STATE OF MAINE  
DEPARTMENT OF TRANSPORTATION  
16 STATE HOUSE STATION  
AUGUSTA, MAINE 04333-0016

June 3, 2022  
Subject: Large Culvert Replacement  
State WIN: 023779.00  
Location: **Stockton Springs**  
**Amendment No. 1**

Please make the following changes to the Bid Documents:

**ADD** the attached Shop Drawings for fabrication of pre-cast concrete box culvert, 8 pages.

STATE PROJECT NO. 23779.10	
STATE OF MAINE CULVERT REPLACEMENT STOCKTON SPRINGS U.S. ROUTE 1, ME	
Drawing No.	INDIVIDUAL PIECE SHOP DRAWING B1
	C24865-B1
Quantity: 1	Project No: WIN 023779.10
	SHEET 4 OF 8
REV	1

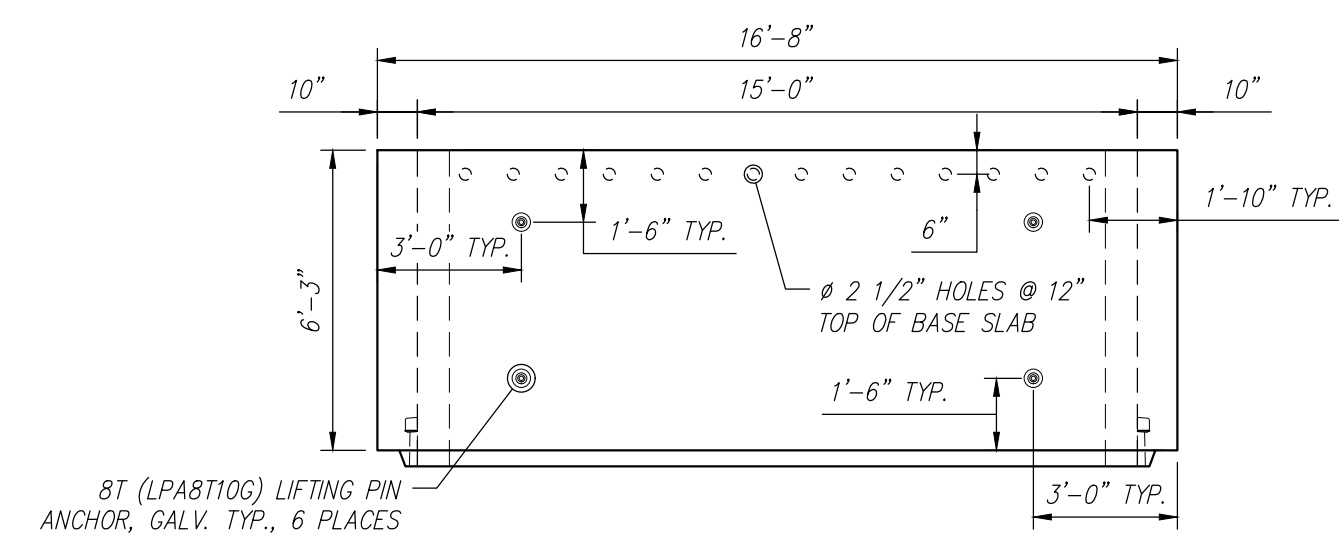
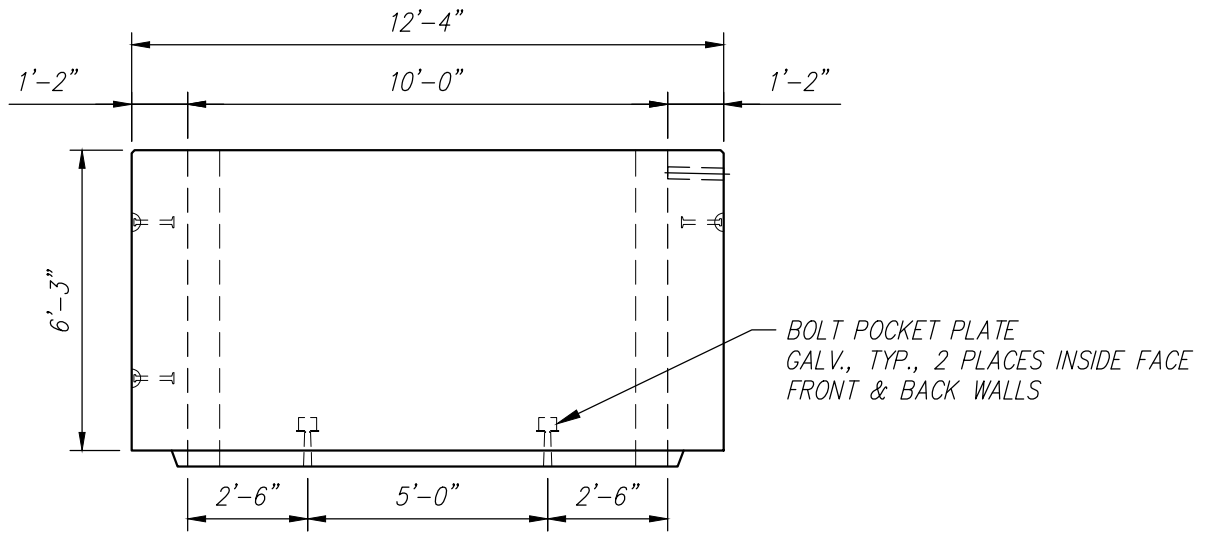
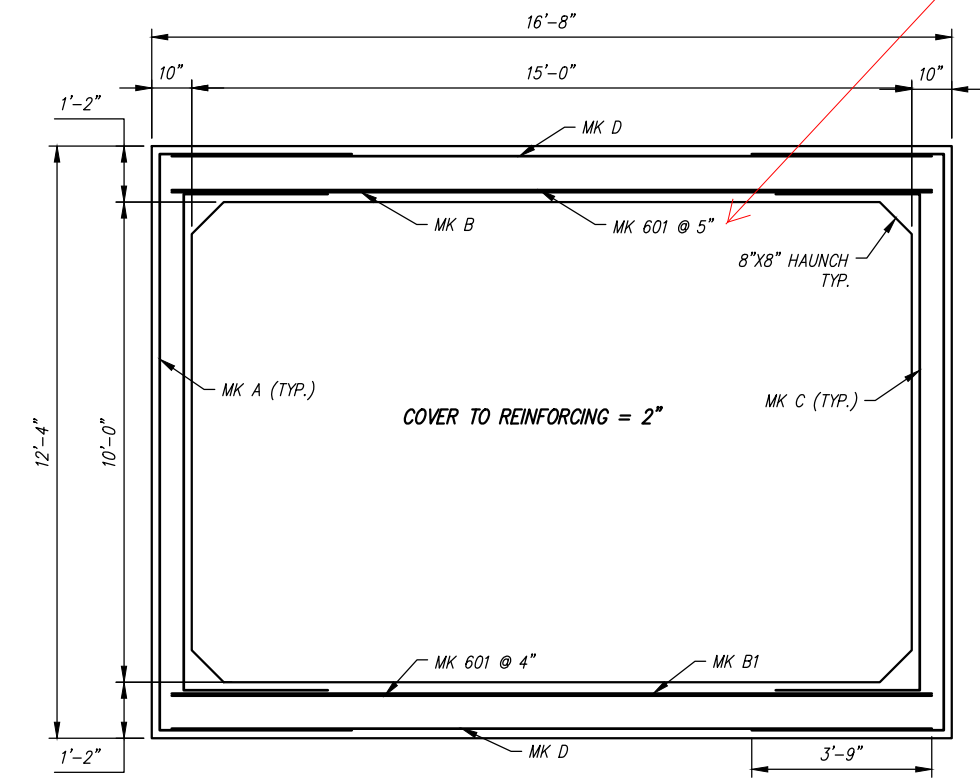
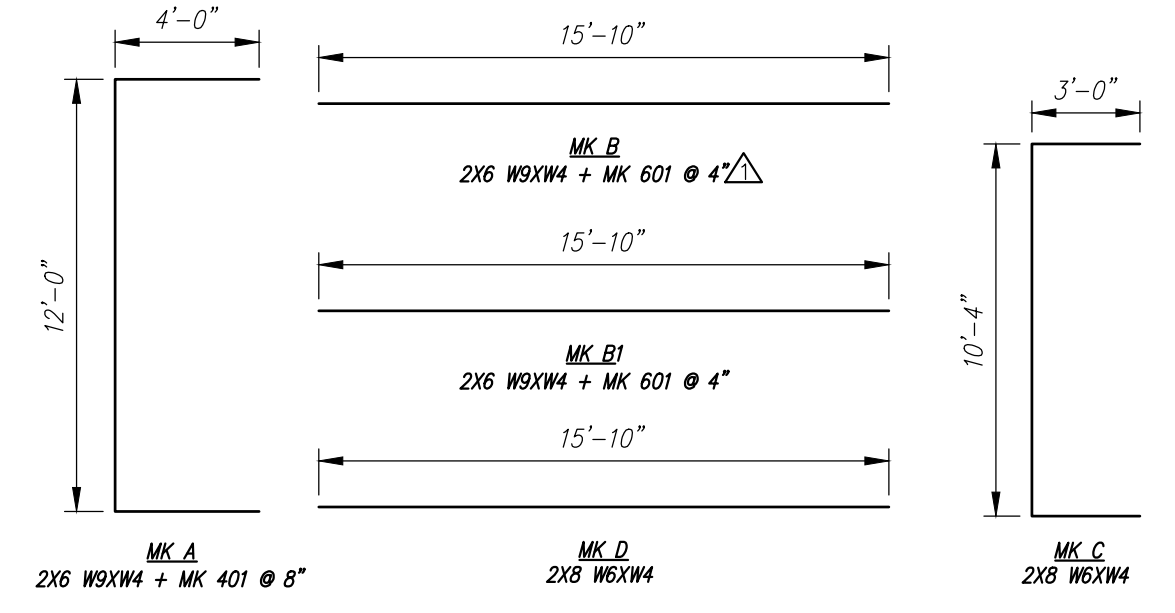
Update to 4" per revised bending schedule

STATE PROJECT NO. 23779.10	
STATE OF MAINE CULVERT REPLACEMENT STOCKTON SPRINGS U.S. ROUTE 1, ME	
Drawing No. <b>D</b> C24865-B2	REV 1 SHEET 5 OF 8

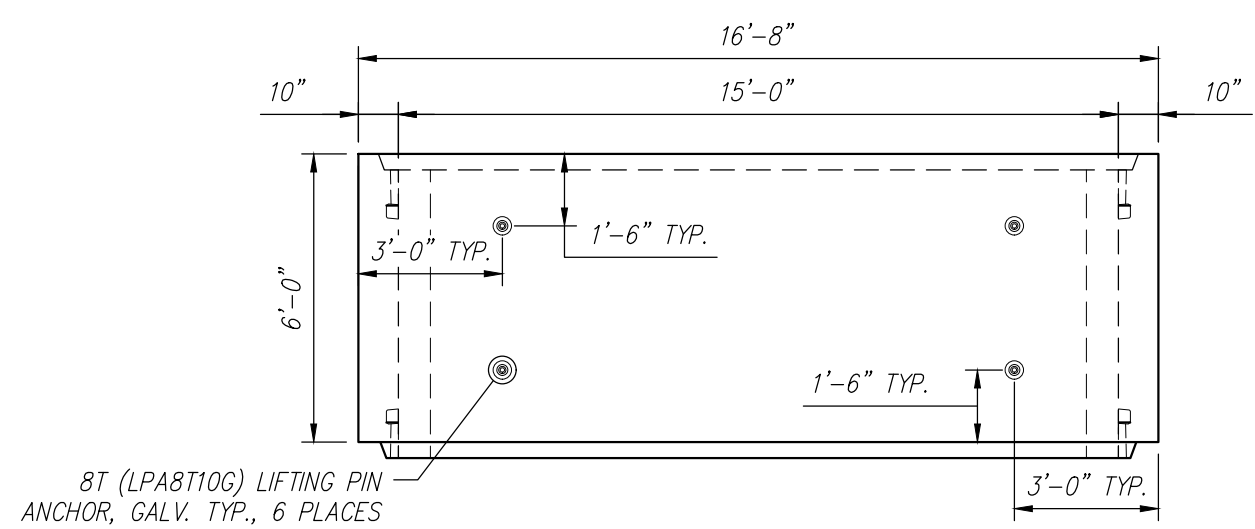
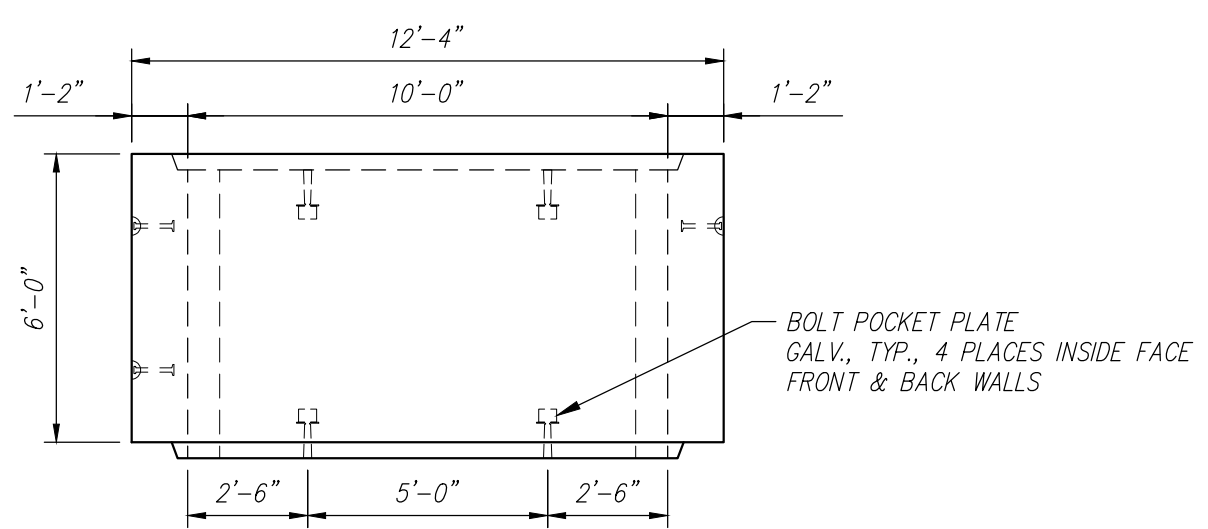
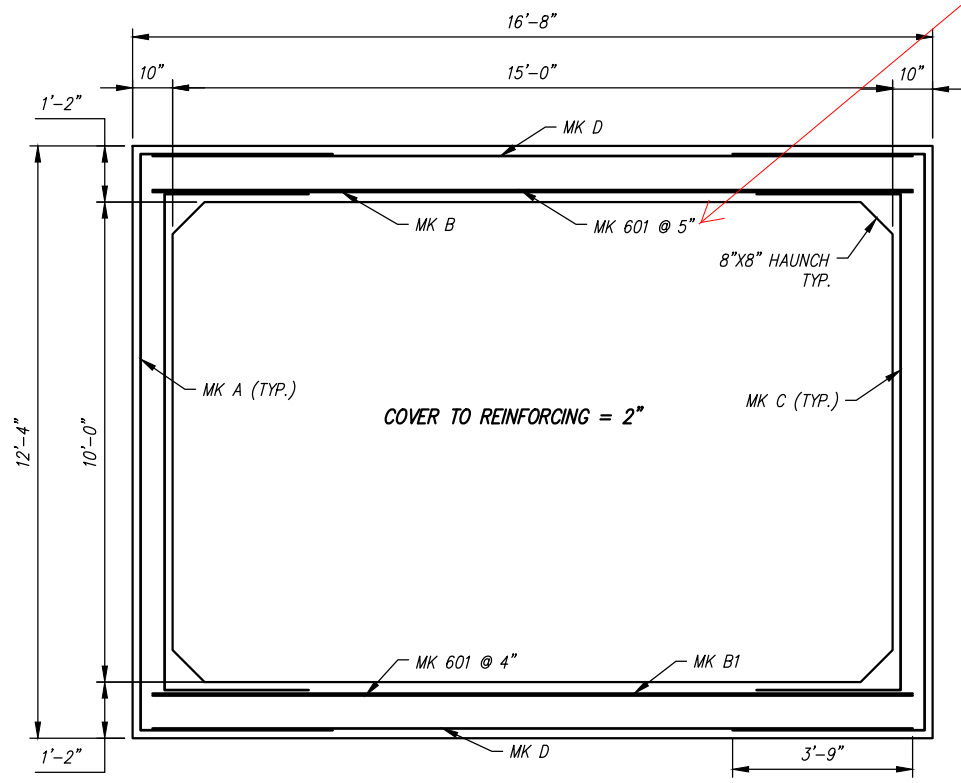
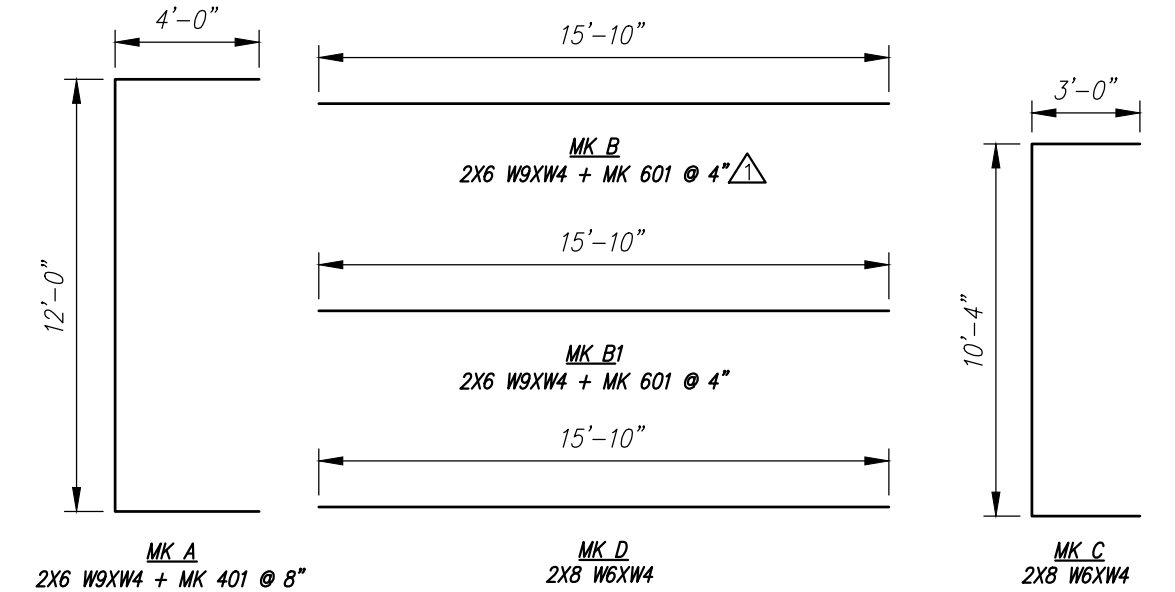
Update to 4" per revised bending schedule

STATE PROJECT NO. 23779.10	
STATE OF MAINE CULVERT REPLACEMENT STOCKTON SPRINGS U.S. ROUTE 1, ME	
D	INDIVIDUAL PIECE SHOP DRAWING B4
Quantity: 1	Project No: WIN 023779.10
REV 1	C24865-B4
SHEET 7	OF 8

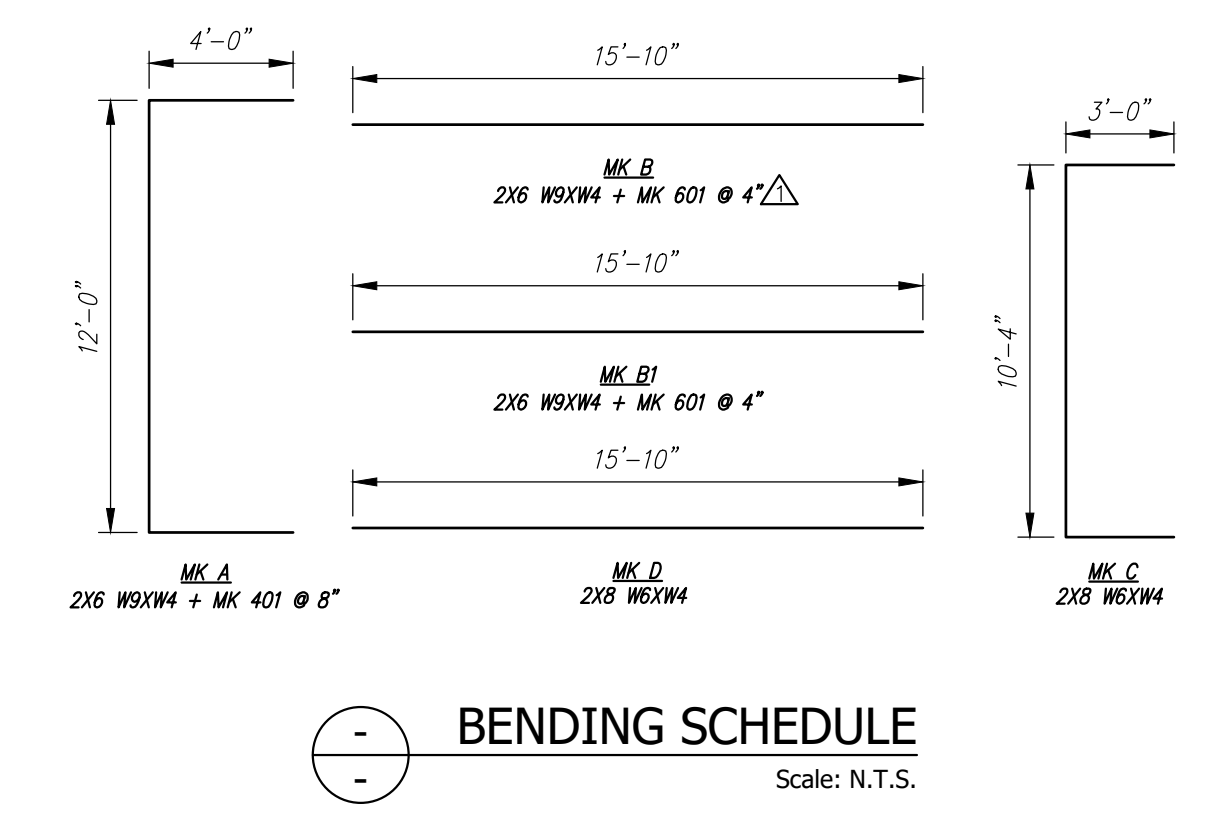
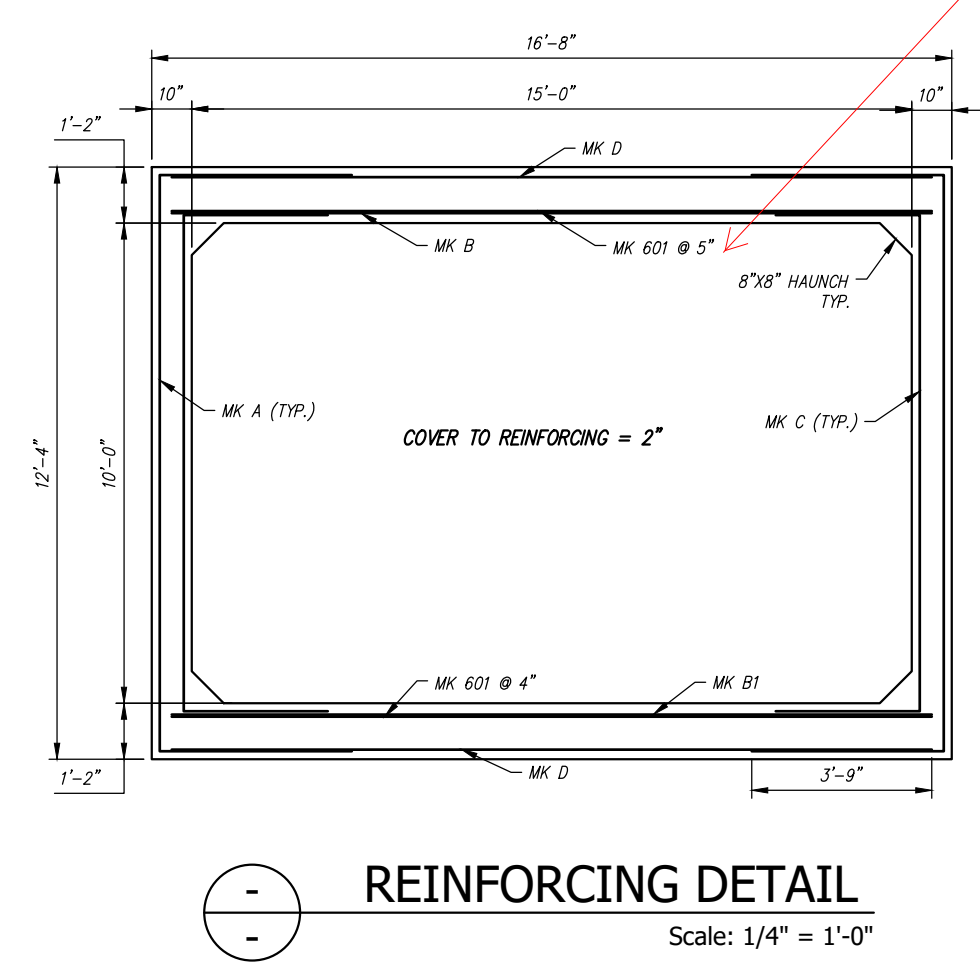
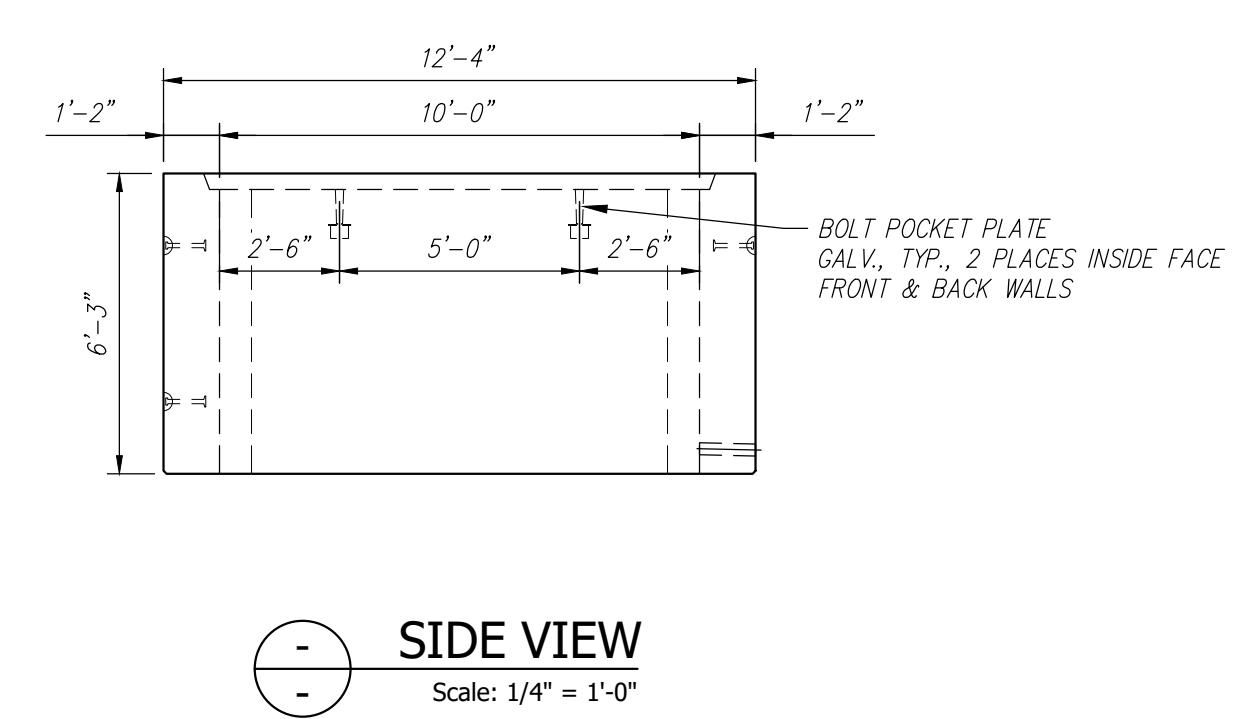
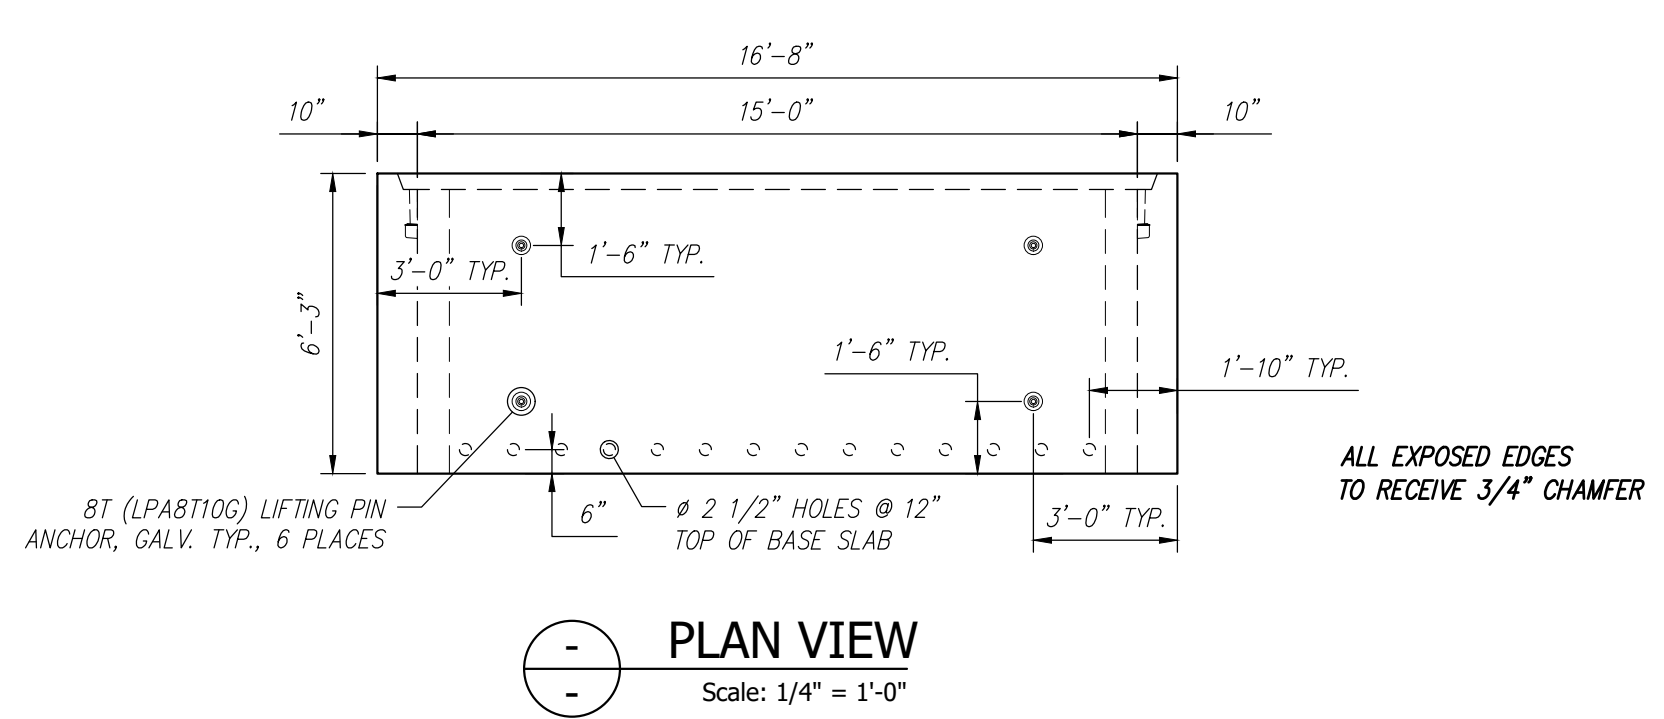
Update to 4" per revised bending schedule
